## 4.5L Information Update

### Models Affected

| Models Covered | Serial Range       |
|----------------|--------------------|
| 4.5L 250 HP    | 2A441953 and above |

The intention of this bulletin is to make dealers and OEM's aware of the following:

**Outboard control**

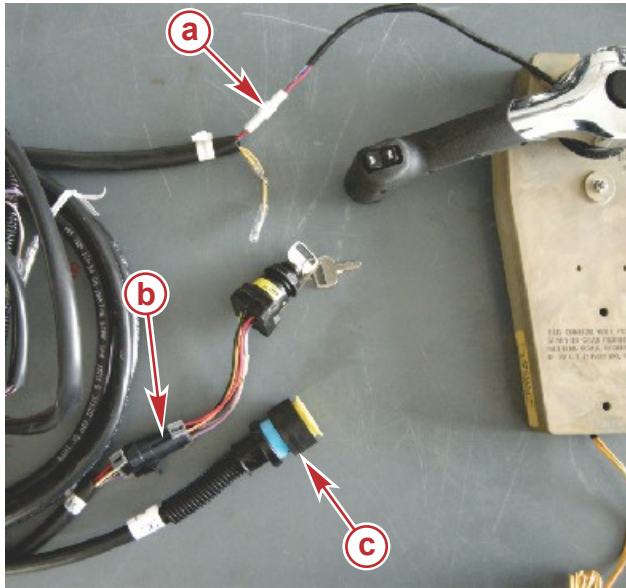
A MerCruiser control or an Outboard control may be used for remote controls, but must be wired properly. Connecting the trim pump or the remote control incorrectly will result in trim that is nonfunctional or a trim limit switch that will not limit trim.

**Fuel module**

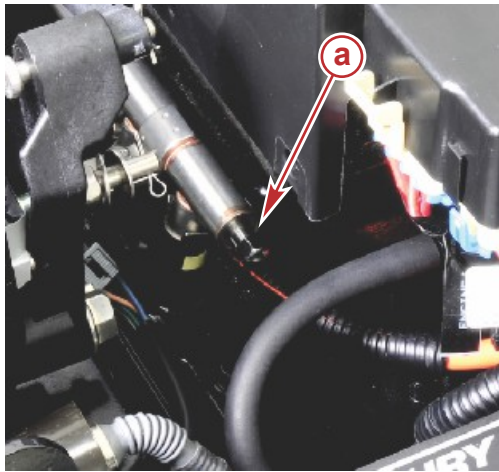
New fuel pressure.

- Idle 41–45 psi
- Static pressure (engine not running) 49–54 psi

## New Front Engine Mount

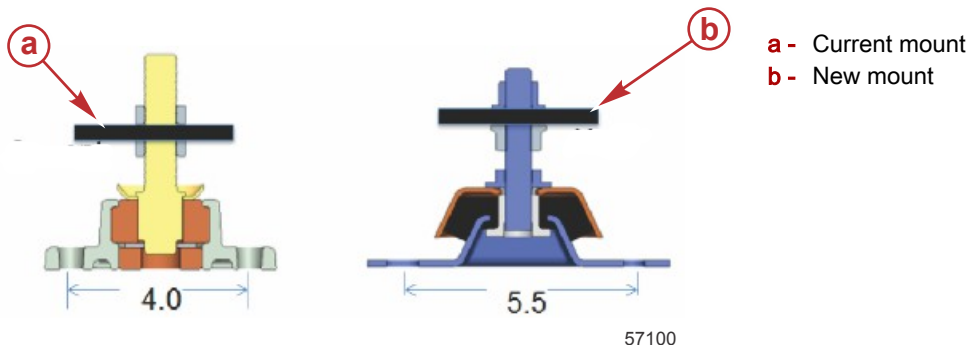
New features for front engine mounts:

- Larger footprint than current mounts

- Nylock top nut
- New locking method for lower nut

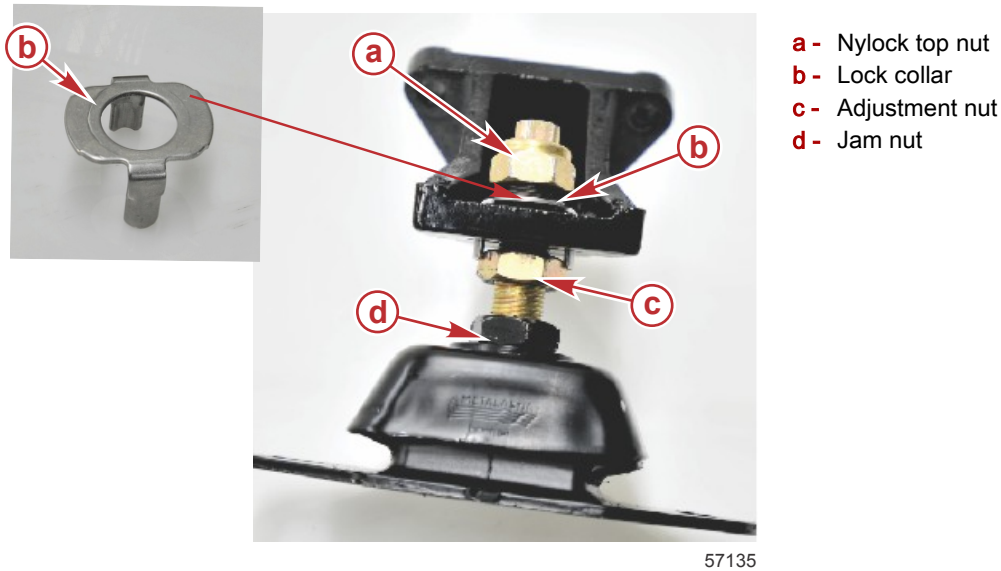
Adjust the mount as follows:

1. The nylock nut must be loosened high enough to disengage the ears of the lock collar.
2. After the lock collar is disengaged, adjust the adjustment nut up or down to get the proper adjustment.  
**NOTE: Do not use the jam nut at any time for adjustment.**
3. When the adjustment is correct, using the adjustment nut, install the lock collar and the nylock top nut.
